V8 XJ Series/XK

303-53

TECHNICAL BULLETIN

Hesitation When Cold – Supercharged AJ 27 Engines – Reflash ECM

ILLUSTRATION 1

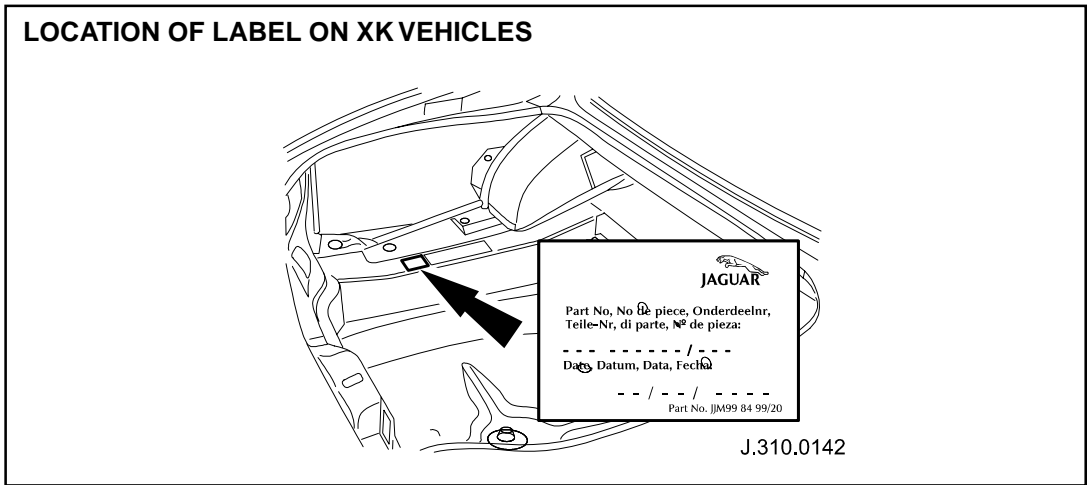
- On XKR vehicles, apply the generic label (JJM 998499/20) alongside the VCATS label in the luggage compartment. Add the revised part number LNG 1410AF and date of re-configuration to the generic update label (Illustration 1).

ILLUSTRATION 2

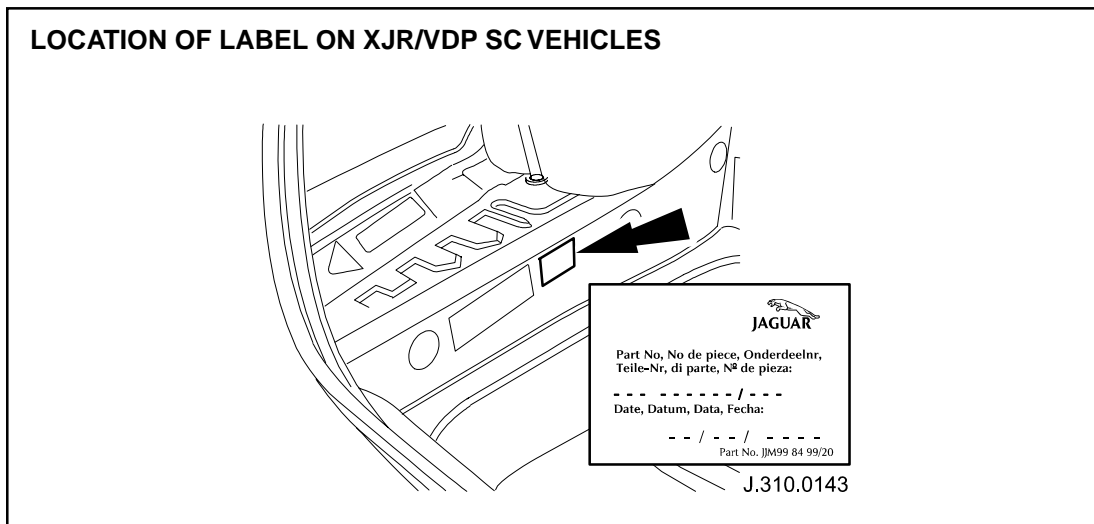
On XJR or VDP SC vehicles, apply the generic label (JJM 998499/20) alongside the VCATS label in the luggage compartment. Add the revised part number LNG 1410AF and date of re-configuration to the generic update label (Illustration 2).
